## **ADDENDUM NO. ONE**

ORANGE BEACH SEWER DEPARTMENT OFFICE BUILDING  
ORANGE BEACH, ALABAMA

ADDENDUM NO. ONE (1) – DATED APRIL 30, 2020

**JOB NO.:**  
**DRAWN:** JAG  
**CHECKED:** SBM  
**DATE:** 2019.07.23  
**REVISION:**  
 ▲ 2019.12.18 STATE REVIEW COMMENTS  
 ▲ ADDENDUM #1  
**SCALE:** 1" = 20'  
**SHEET NO.:**  
**C1.0**  
 SITE PLAN

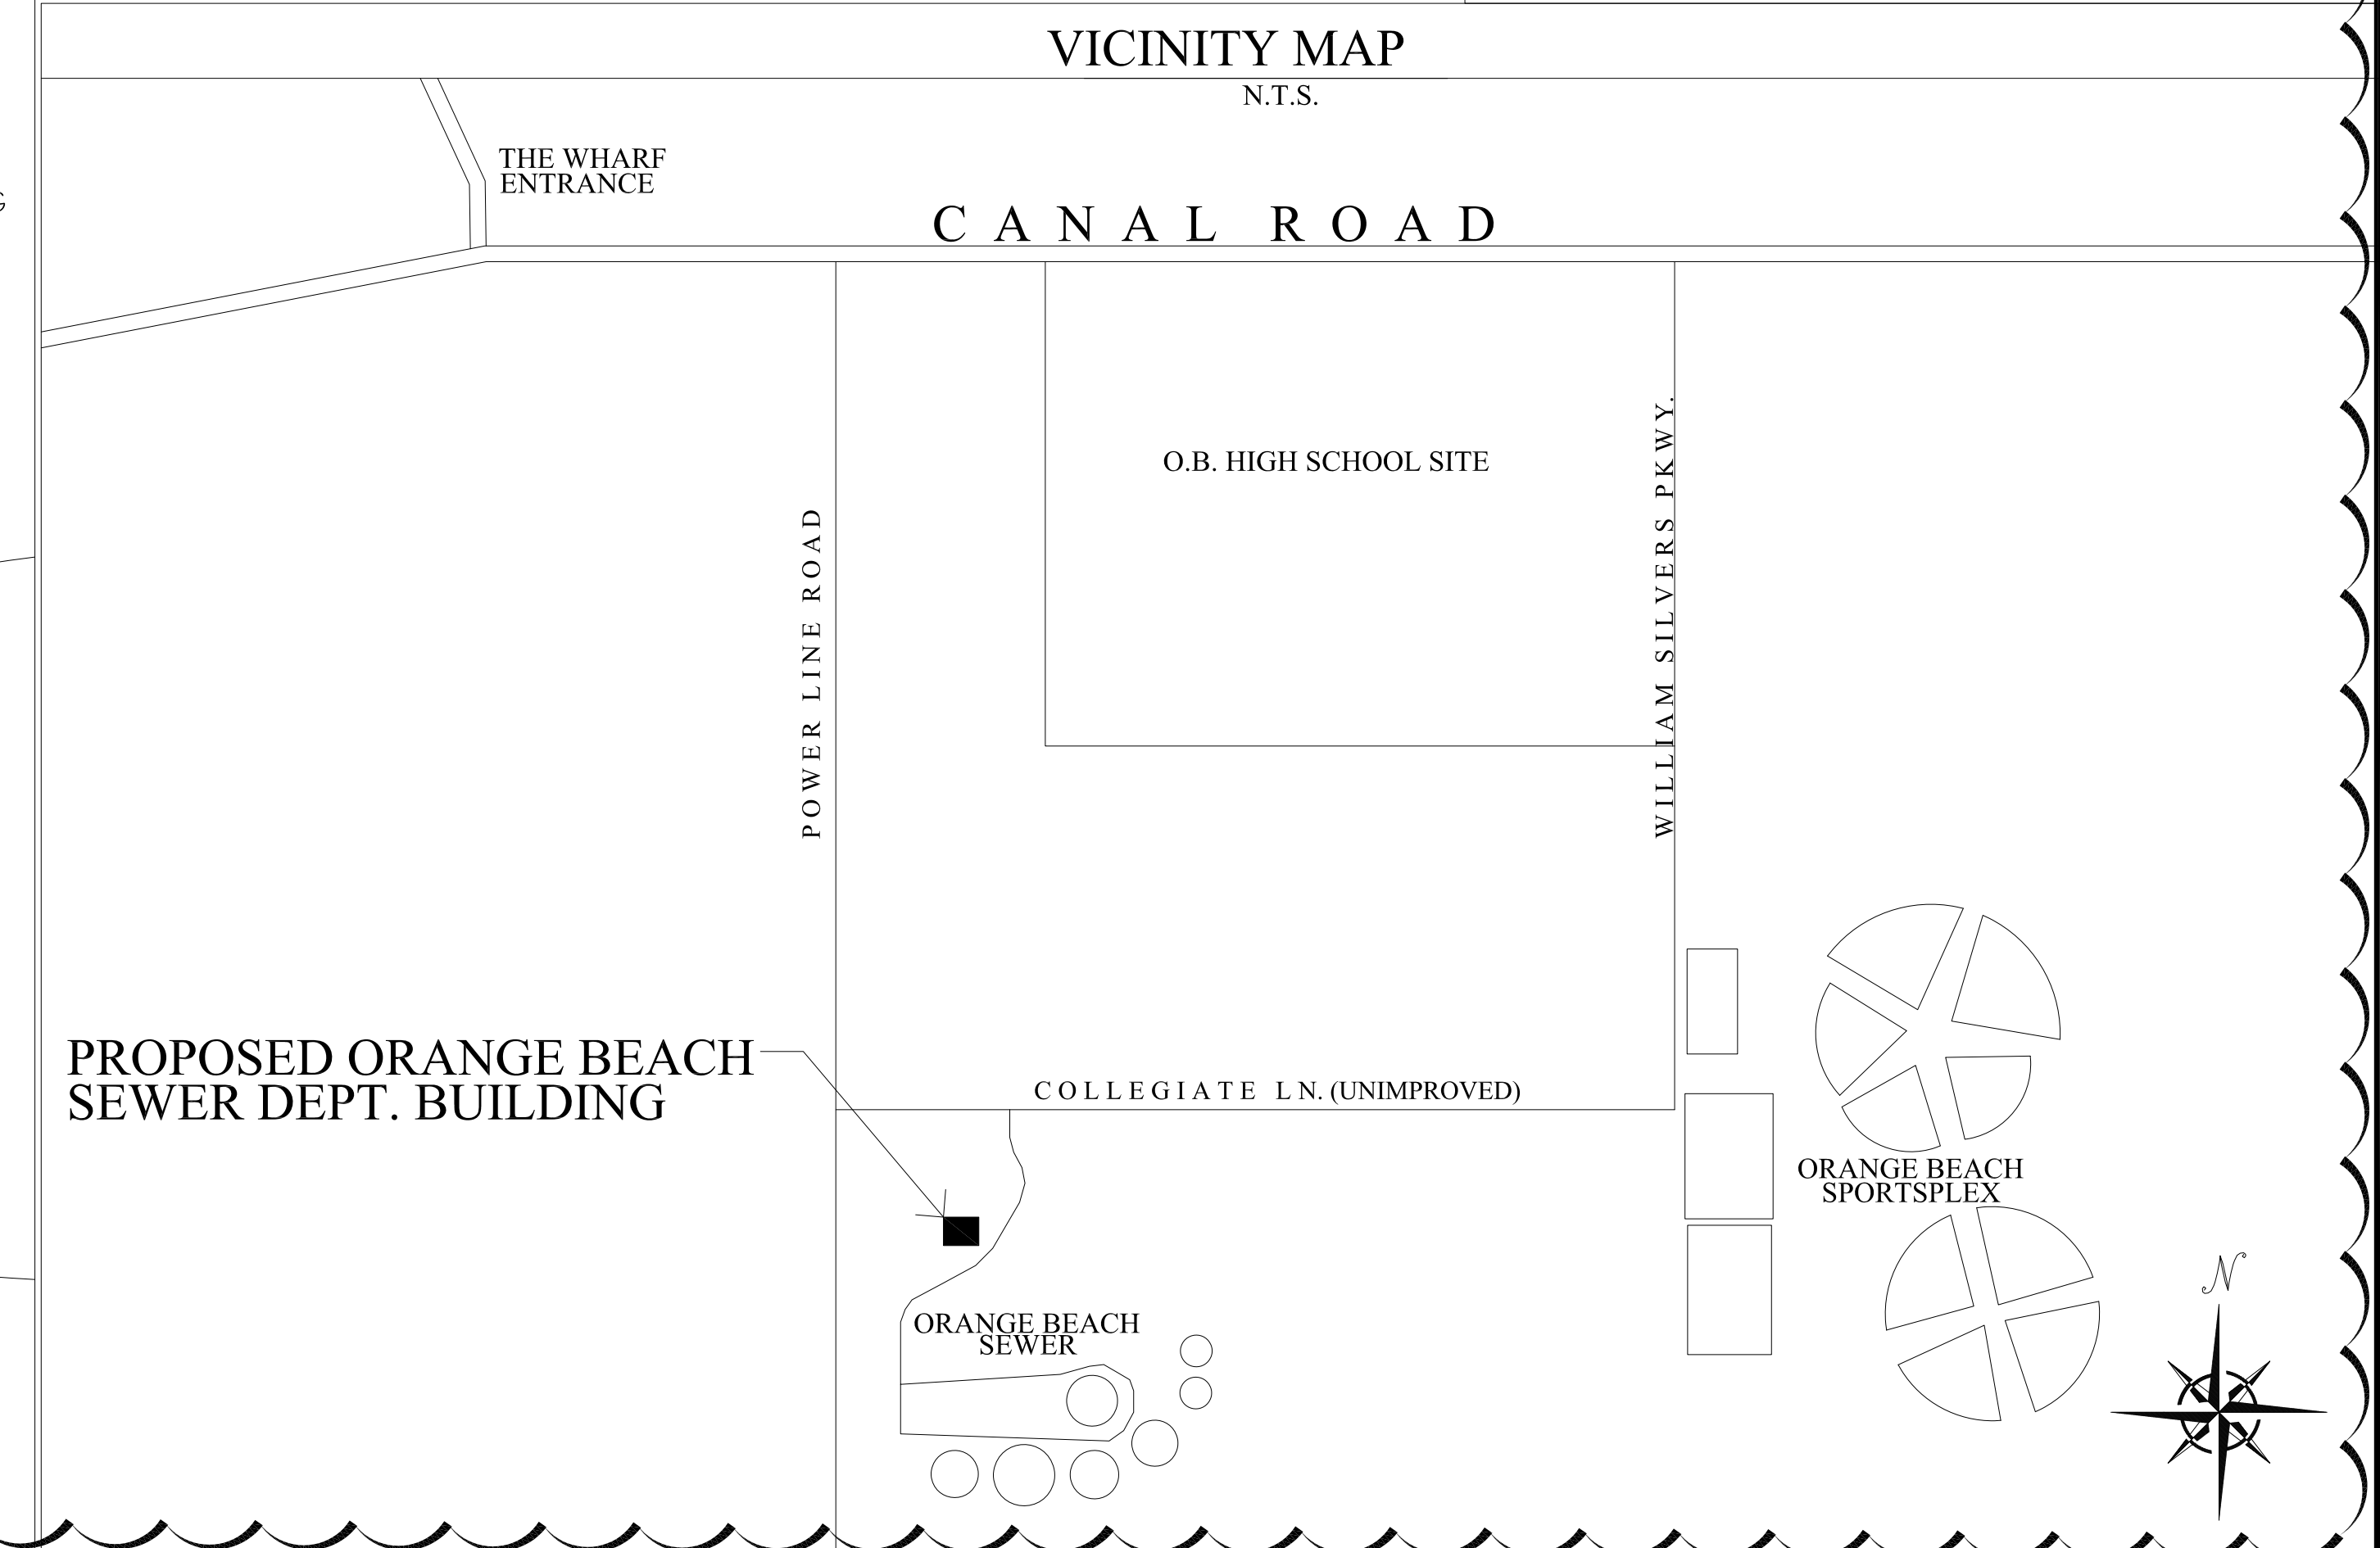
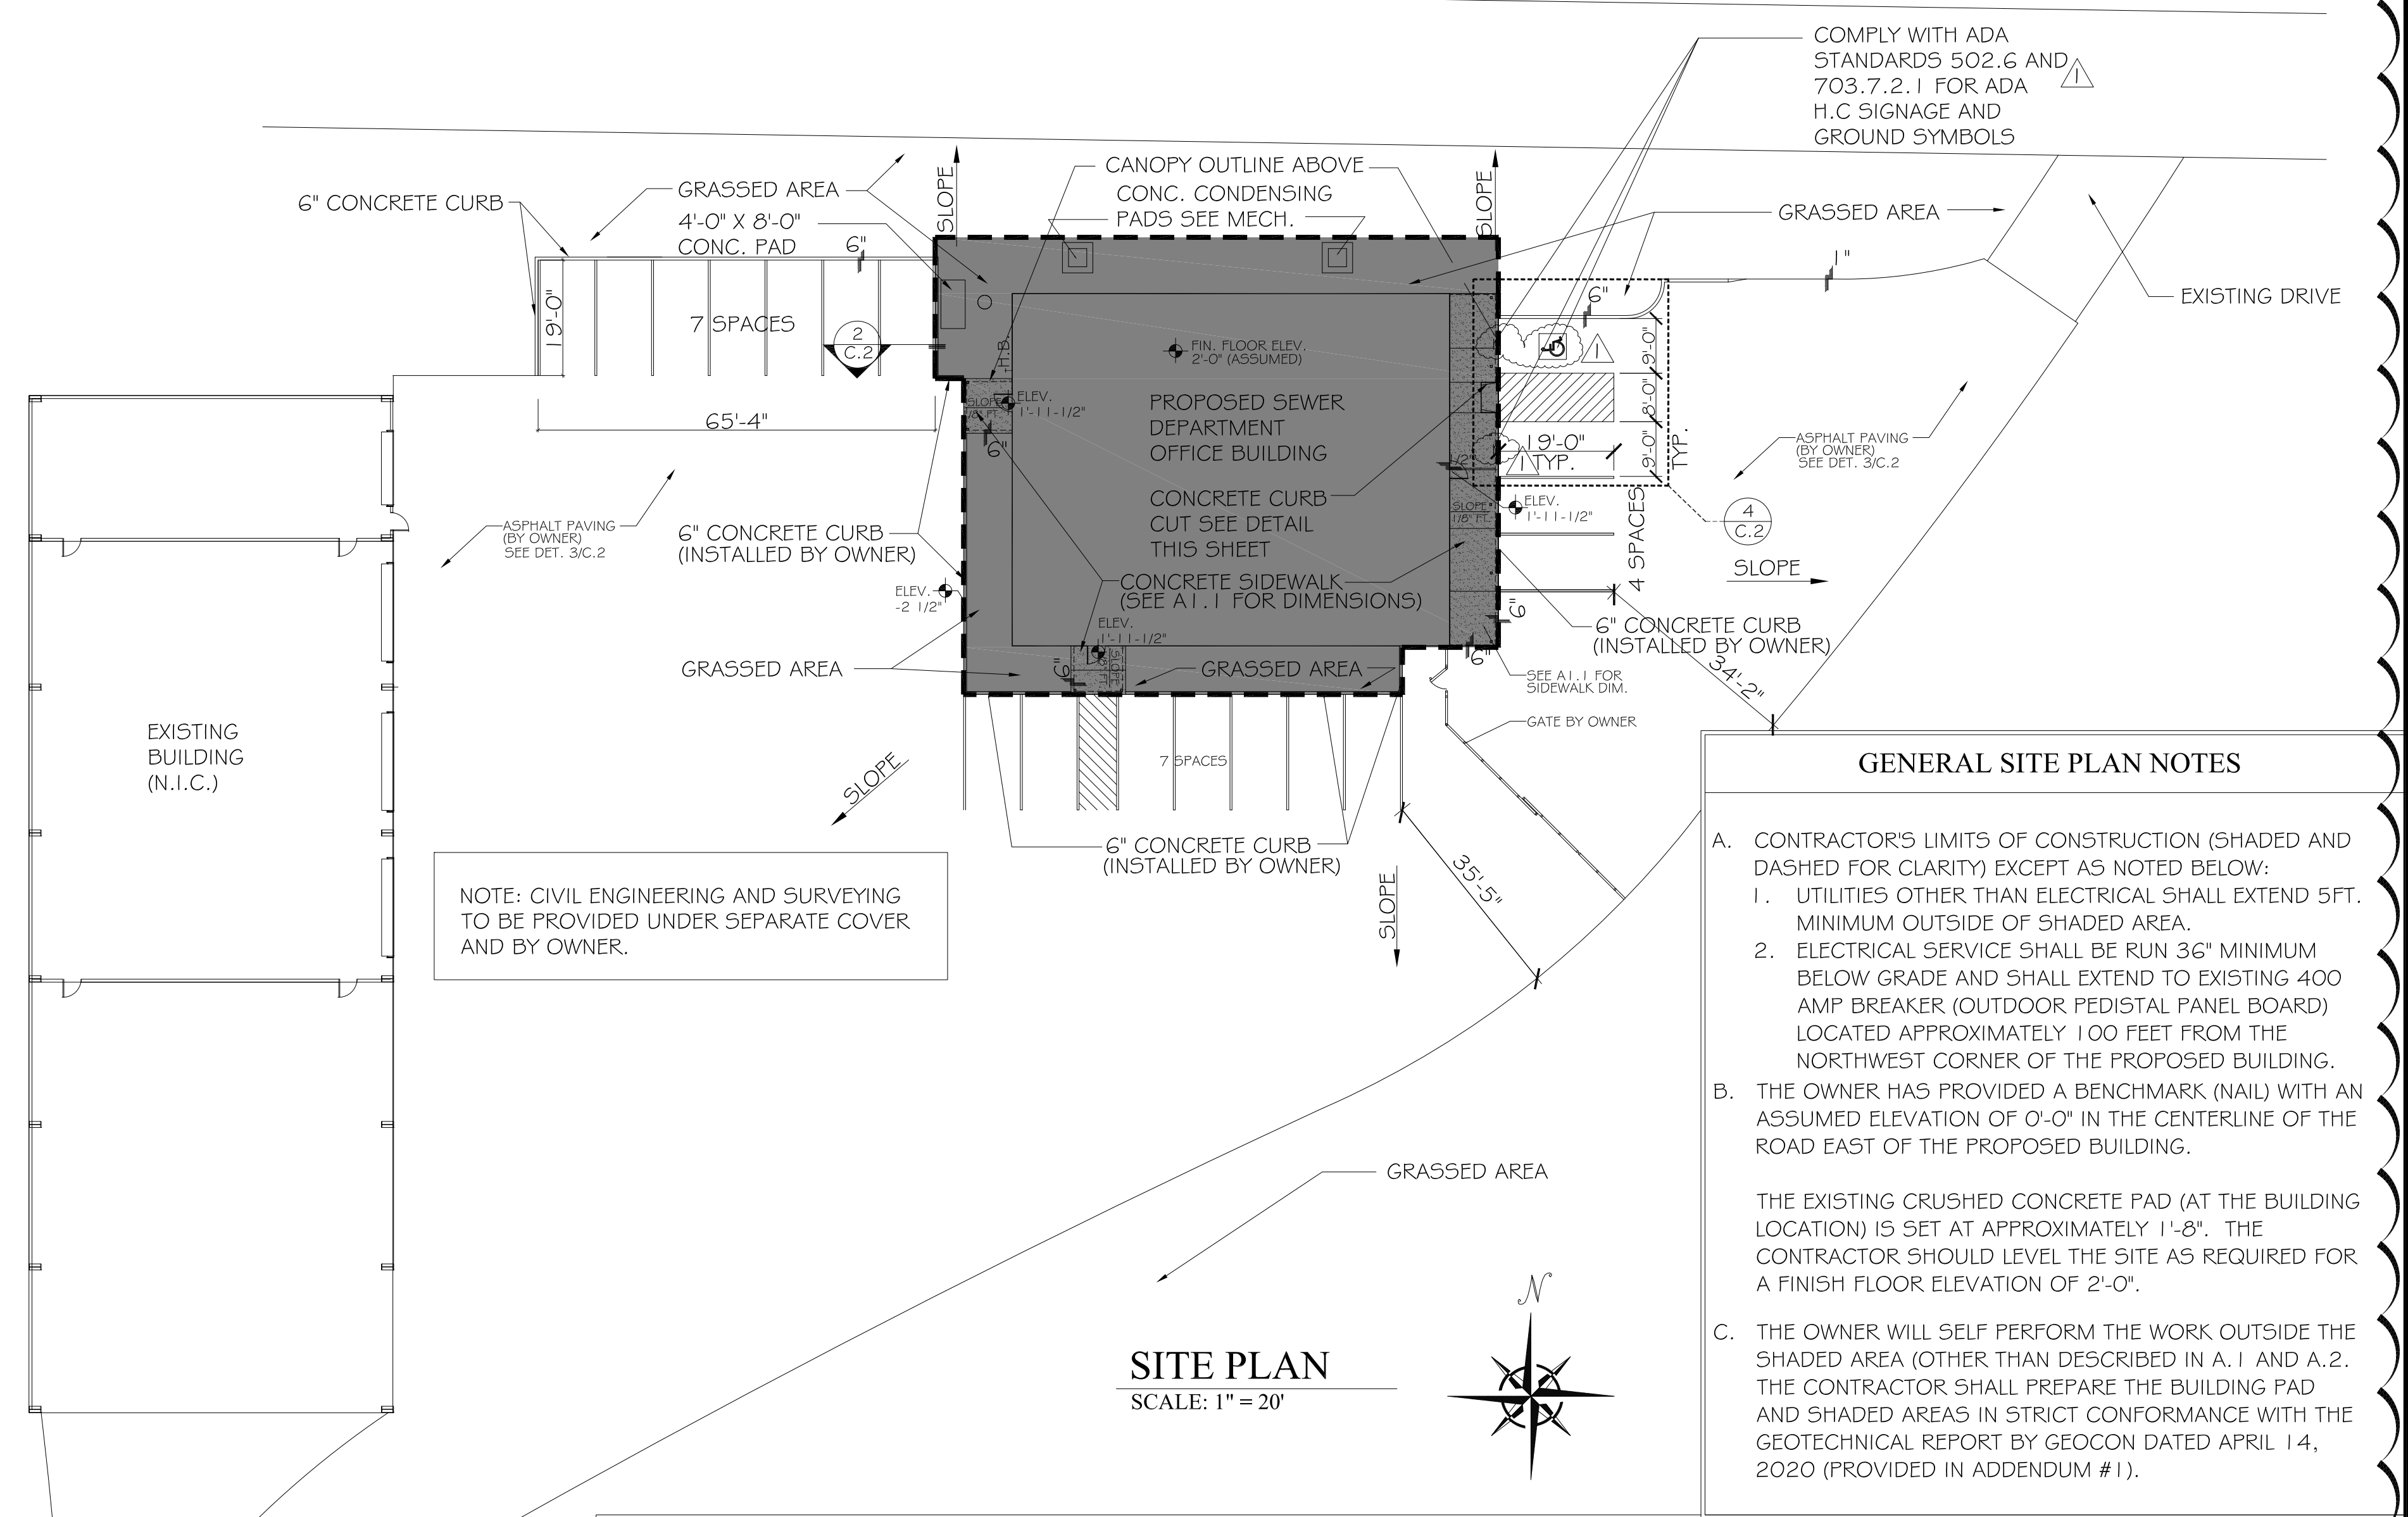
**2. Sheet C1.0 - ATTACHED**

- a) See revised sheet.

**FOUNDATION PLAN**  
SCALE: 1/4"=1'-0"  
FINISH FLOOR = +0'-0" U.N.O. (REF. CIVIL/ARCH)

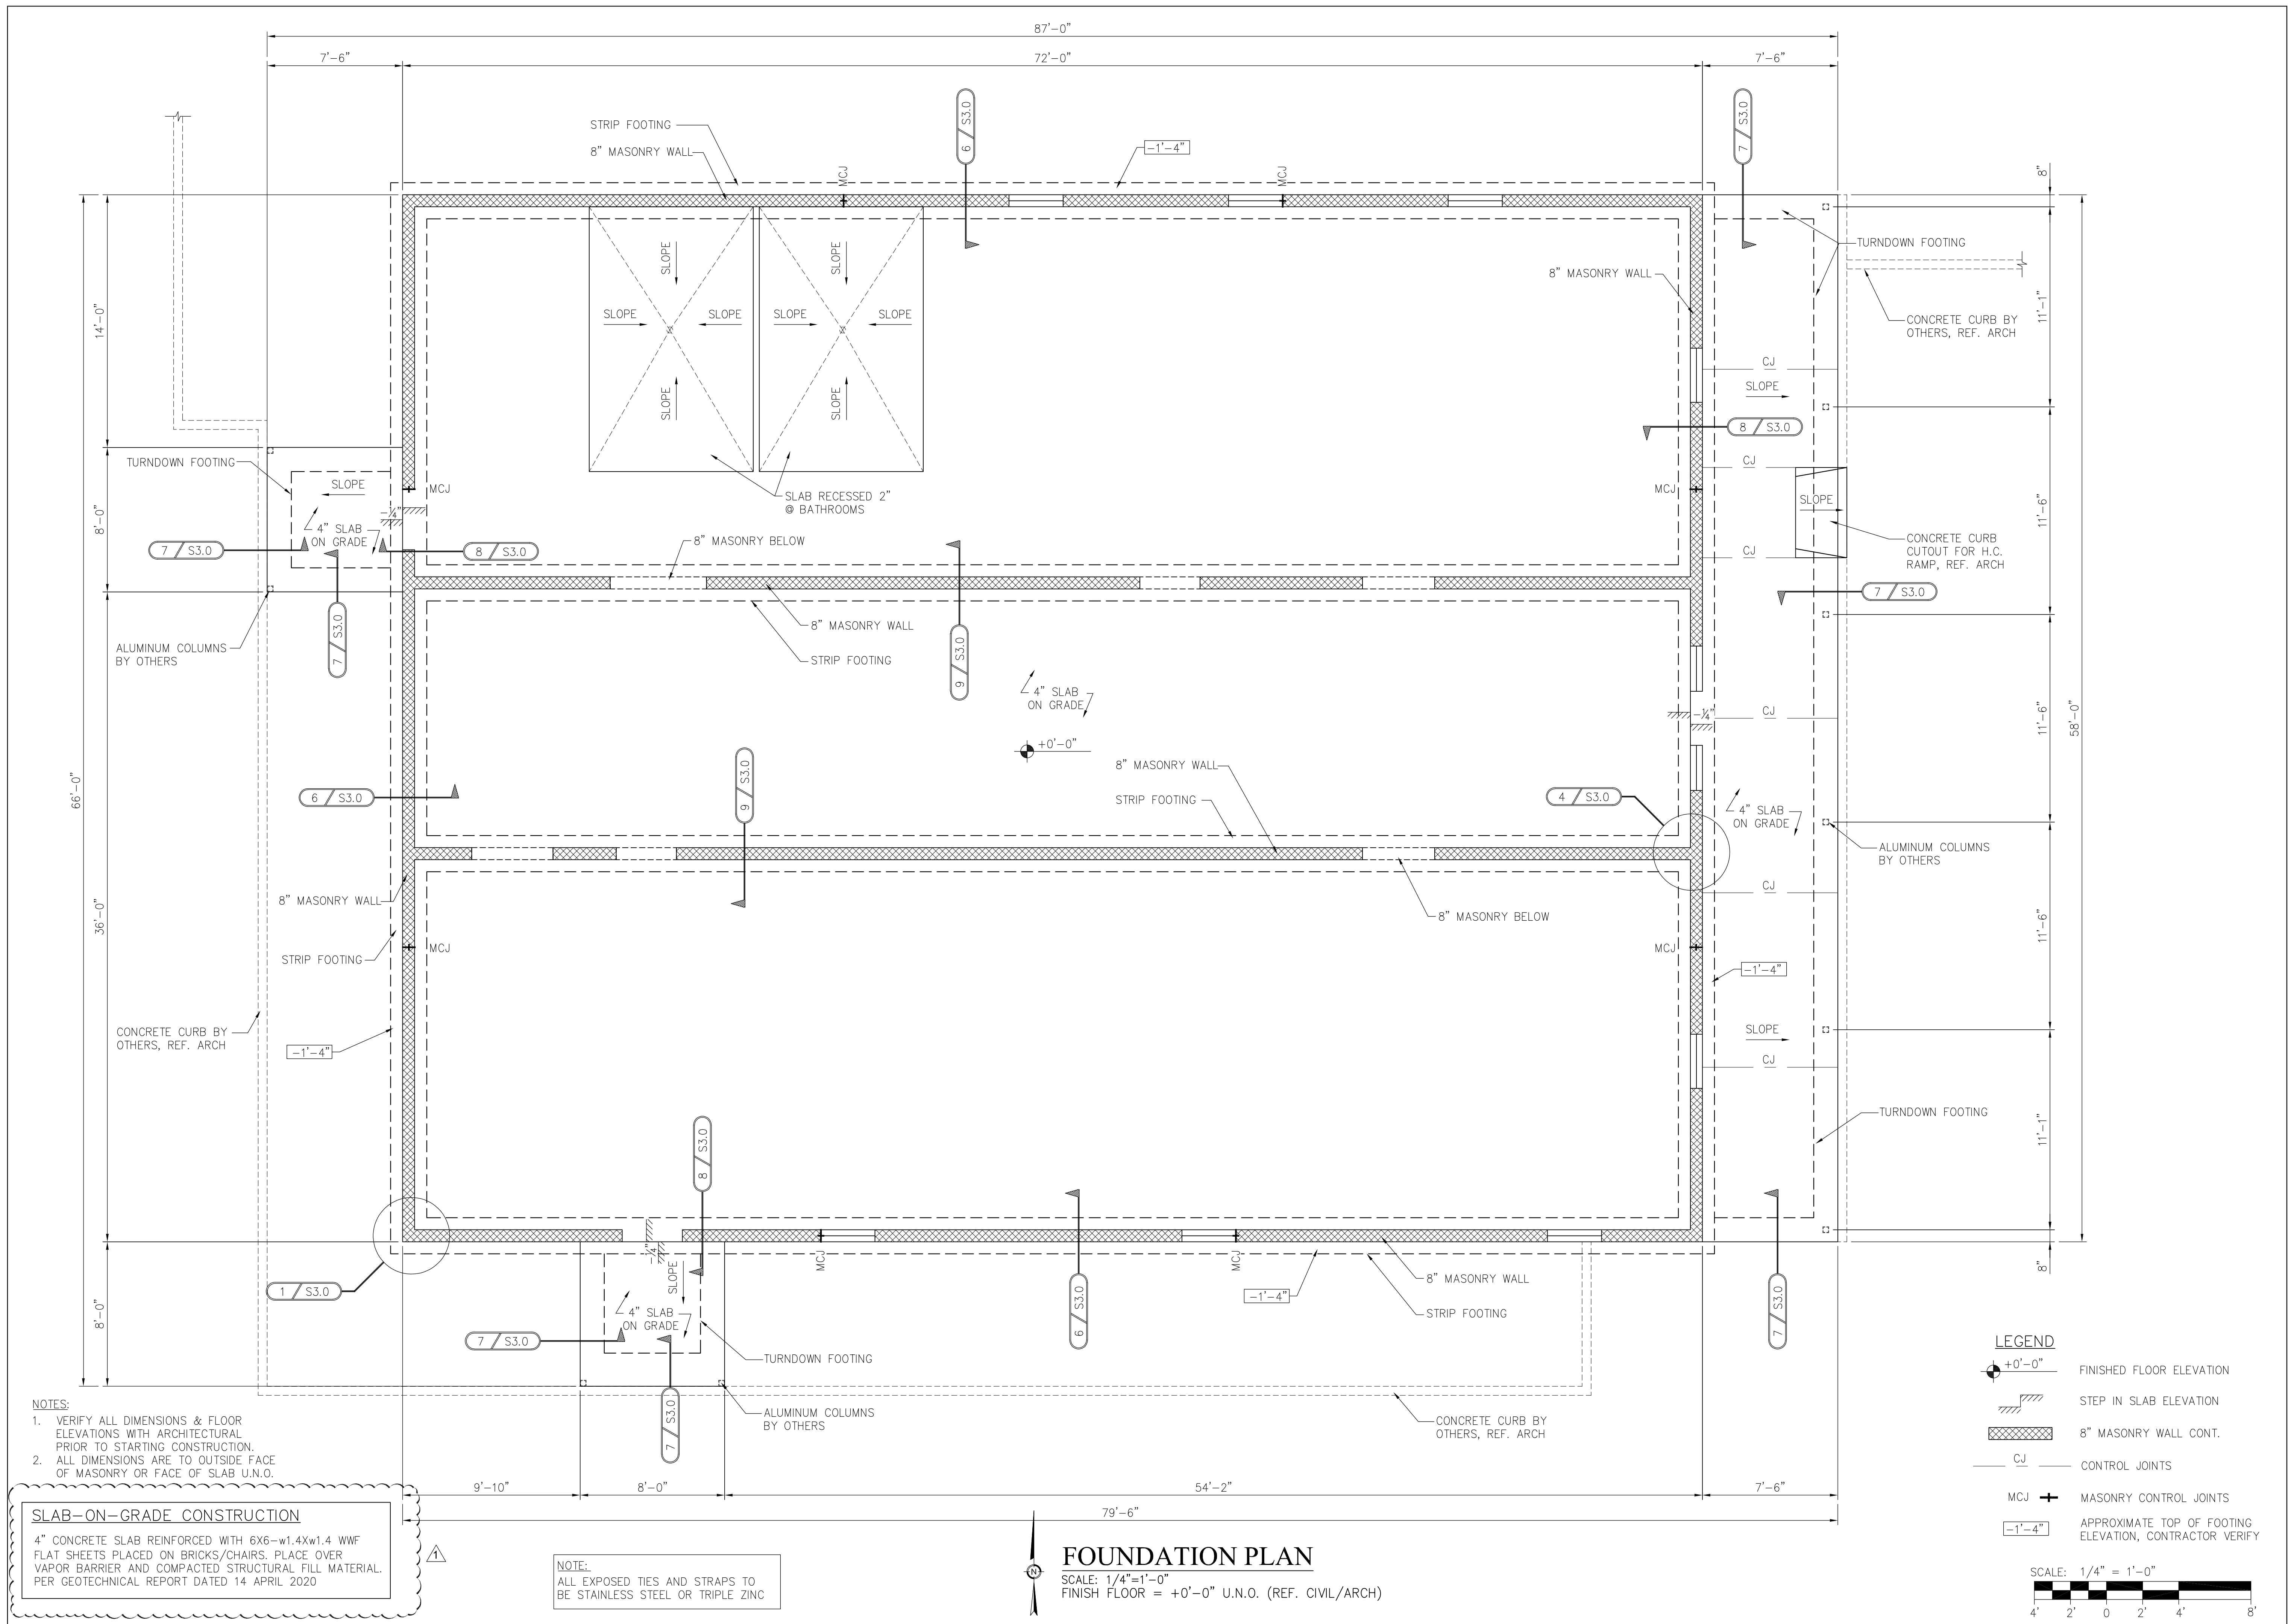
**1. Sheet S0.0, S1.0, S2.0, S3.0, S4.0 – ATTACHED**

- a) Please see attached revised structural drawings and note that in addition to other changes indicated, all masonry cells are to be grout-filled.
